# Sheringham Shoal and Dudgeon Offshore Wind Farm Extension Projects

Apportioning and HRA Updates Technical Note  
(Revision E) (Clean)

Document Reference: 13.3

Table 5-2: Natural England consultation summary (Based on Rev B Note [REP2-036] at Deadline 3, received May 2023)

Title: Figure 2 Overlap of SEP 10km buffer not impacted by existing OWFs

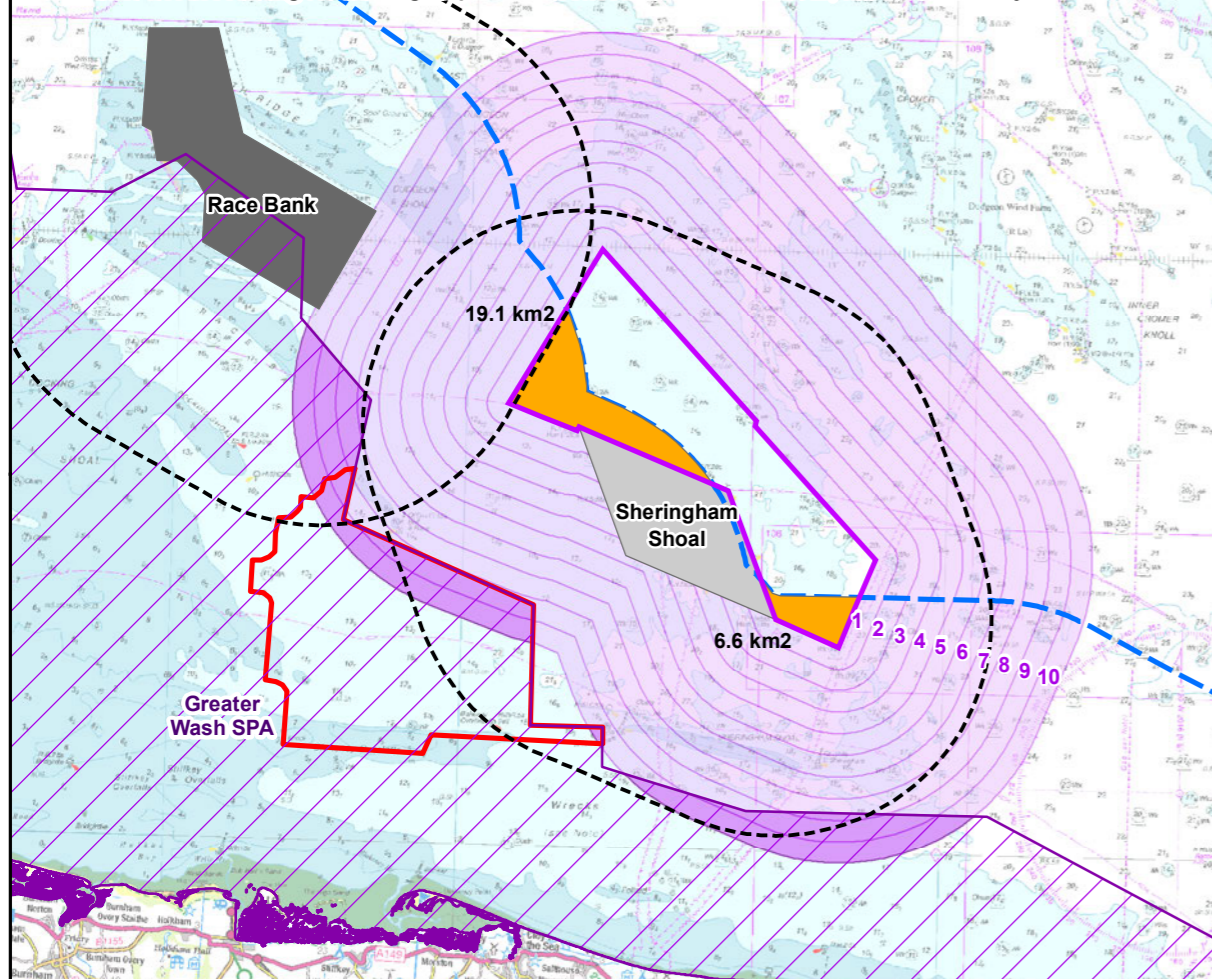
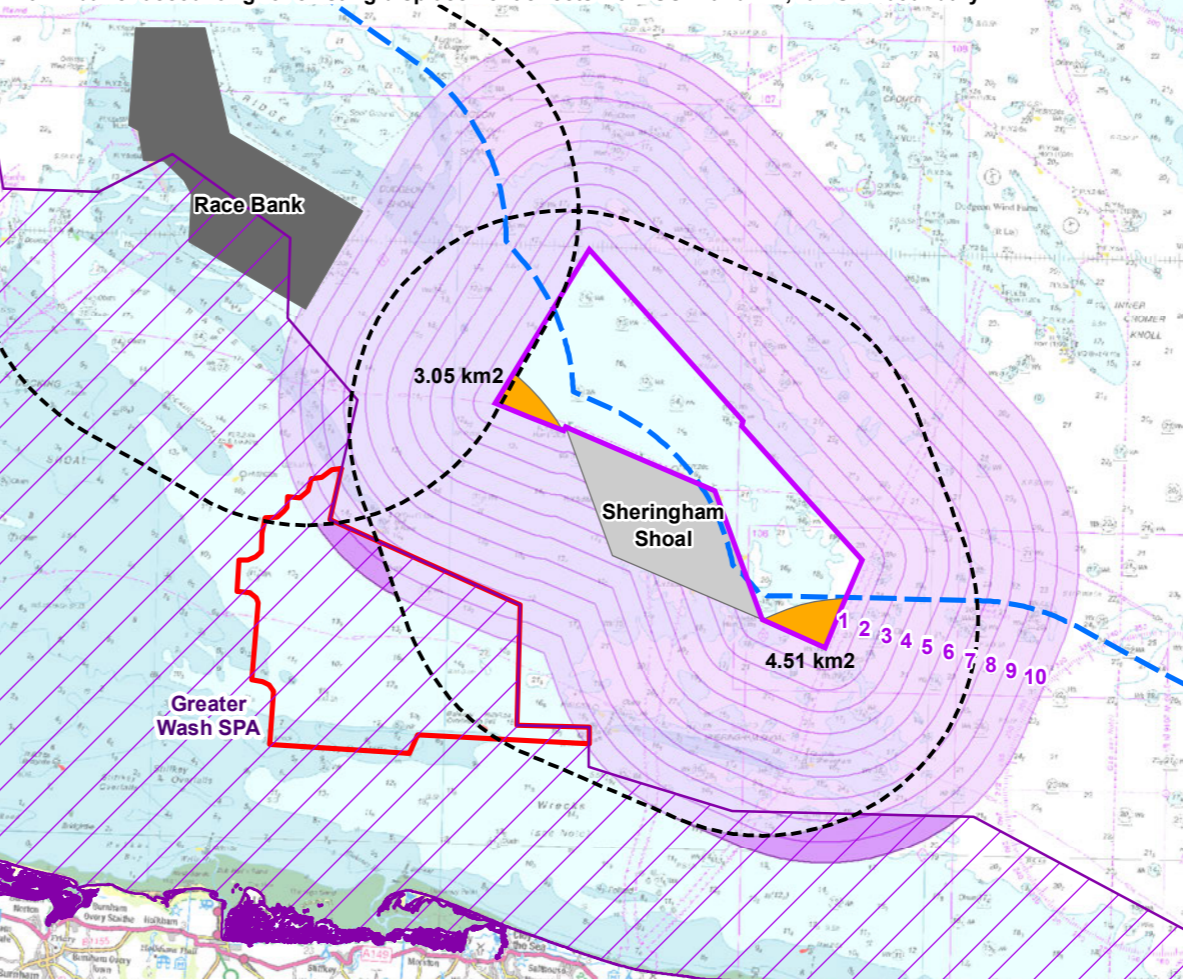
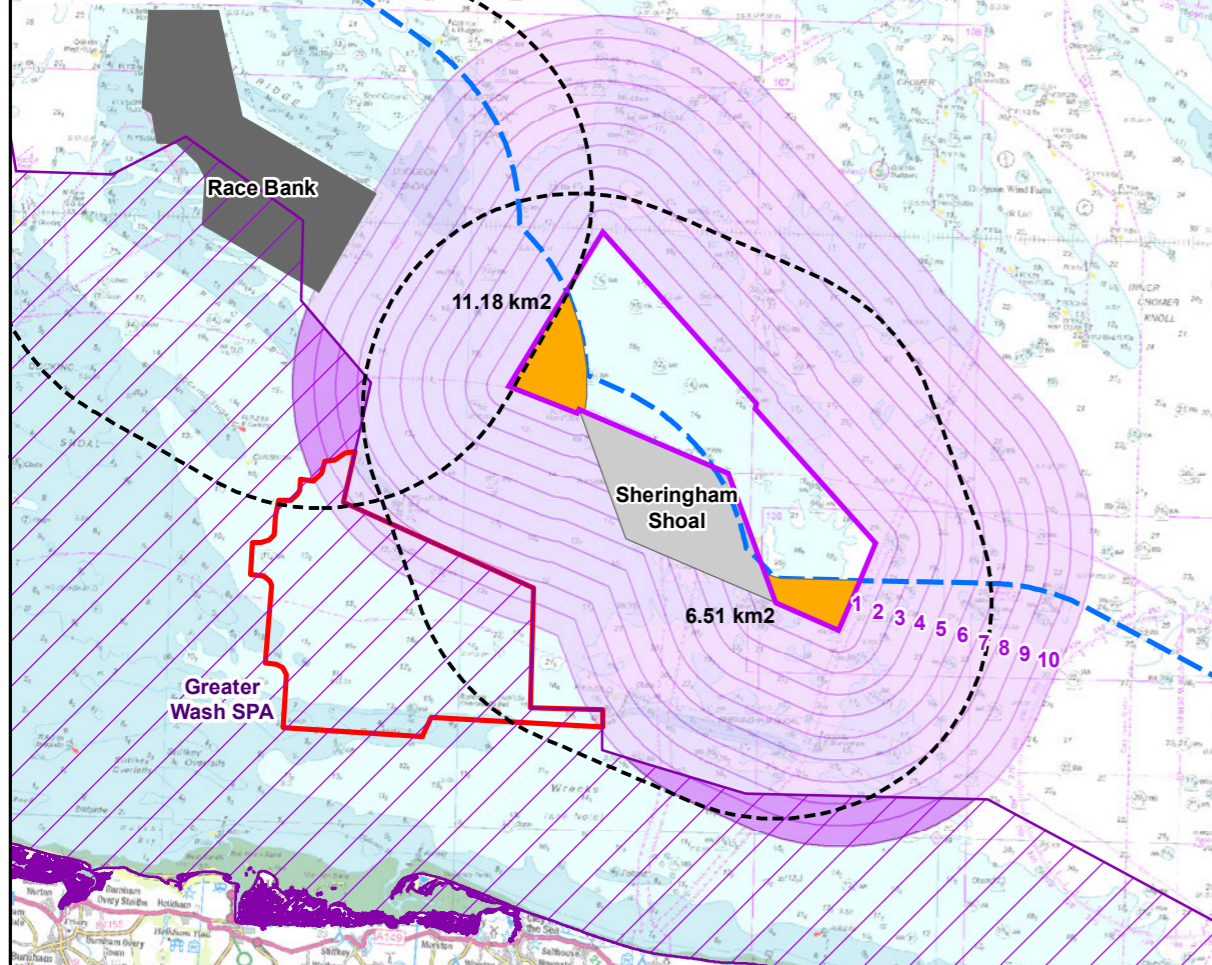
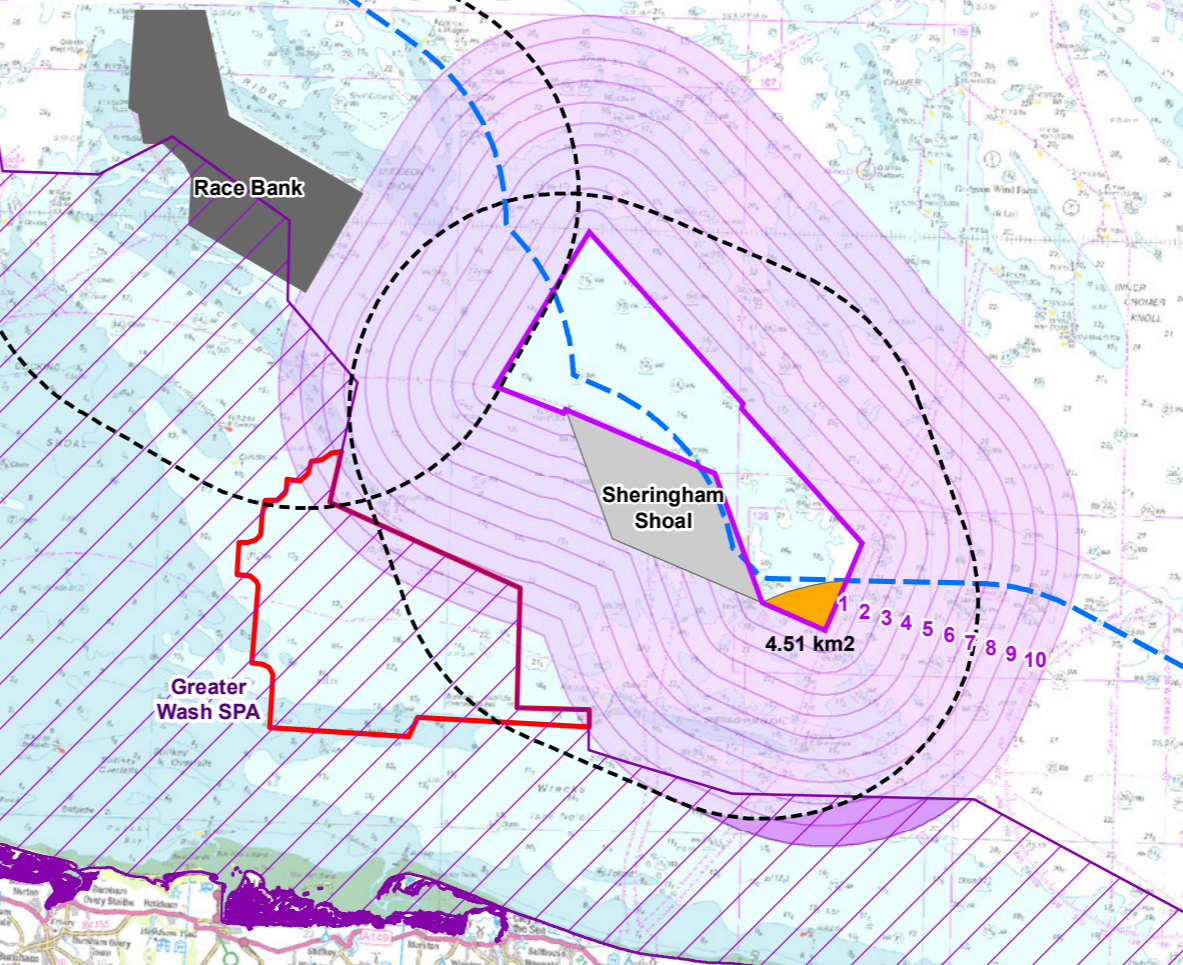
22	11. GW SPA RTD	99	As recognised by the Applicant in the RIAA, excluding areas that overlap existing OWFs from the calculations of area over which displacement could occur as a result of SEP alone does not account for the potential increase in the magnitude of impact in these areas if SEP is closer than the existing OWFs, and therefore this is likely to be an underestimate. Furthermore, even if SEP is further away, it is plausible that it could exert an additional displacement effect. Therefore, Natural England consider that the real project alone impact	The Applicant has updated values in <b>Table 14-3</b> and <b>Table 14-4</b> to account for buffer overlap areas where the effect of SEP would be greater than from existing OWFs. This has slightly increased the effective area of displacement from 0.16% to 0.22% (where all of the SPA boundary is included) and 0.12% to 0.17% (where the area outside of the red-throated diver MCA is excluded).

ID	Section of draft document	Paragraph	Natural England comment	Applicant response
			<p>will lie somewhere within the range of 0.41% - 1.77% for the percentage of the total area of the SPA subject to displacement (and 0.12% - 0.56% for the 'effective area of displacement') based on the SEP buffer zones as presented in tables 11-3 and 11-4.</p>	<p>The Applicant maintains that it is reasonable to exclude areas already impacted by OWFs from the effective area of displacement. If this were not the case (and that Natural England's assertion that SEP could exert an additional displacement effect, even when it is more distant from a given point than existing OWFs was correct) then this would suggest that the shape and/or size of a windfarm array would result in a different level of effect at a given distance from the array boundary. The Applicant is not aware of any evidence for such a difference, and Natural England's recommended approach for calculating displacement effect does not take this into account.</p>

i.e. within the red-throated diver MCA and outside areas within 10km of existing windfarms, is 6.03km<sup>2</sup> or 0.17% of GW SPA; the net impacted area is shown hatched green on **Figure 2**. As DEP is more than 10km from the Greater Wash SPA, no effects are predicted for this OWF.
